# Technical Bulletin

## TB 0249 – LV overhead road crossing network mains supplying LV road clearance poles

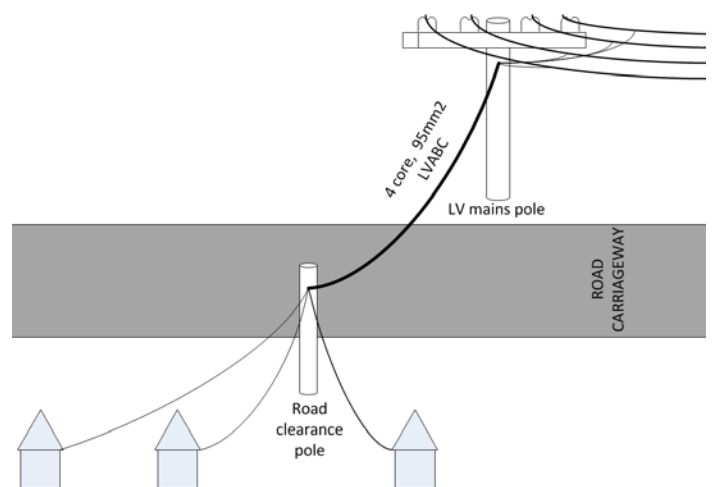
MDI 0031 clause 3.4.4 states that:

- a "4 x 25 LVABC may be used to cross a road and supply up to two customers" and
- "4 x 95 LVABC is the minimum requirement to supply greater than two customers".

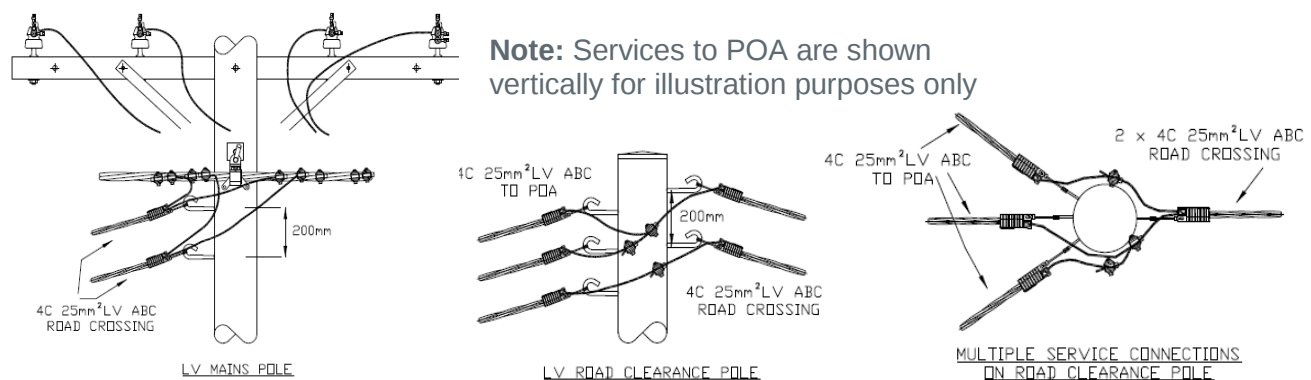
As part of existing service mains upgrades, two 4C 25mm<sup>2</sup> LVABCs may be used as road crossing network conductors in place of a 4C 95mm<sup>2</sup> LVABC for connecting between a LV mains pole and LV road clearance pole with each 4C 25mm<sup>2</sup> LVABC to supply no more than two customers.

Each 4C 25mm<sup>2</sup> LVABC must be installed on individual 'J' hooks as illustrated in the figure below.

The ground clearances for LVABC mains and service cables must be in accordance with clauses 5.1.1 and 5.1.2 of MDI 0031.
